Access Compliance Report

Public Rights-of-Way

(Pedestrian Signals)

Intersection ID: N/A	Main Street:	Cross Street: N/A	Location: N/A
ADA ID: B726581926E9	Signal Type: One Push Button-APS	Overall Compliance: No	Severity Score: BTN 1: N/A BTN 2: N/A No BTN: N/A
Codes/Mitigation Info/Possible Solution		Field Measurements/Component Compliance

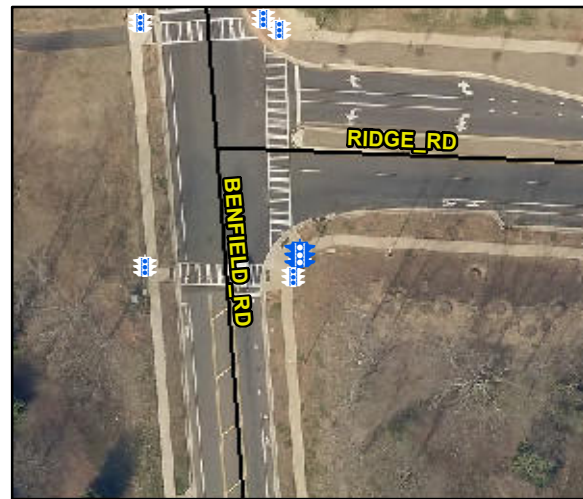
Possible Solutions: Replace Signal Push Button With APS Button on New Post. Remove & Relocate Sign.

PROW/ADA: TMUTCD 4e.08, R404.2, R404.3, R209.1, MUTCD 4e.10
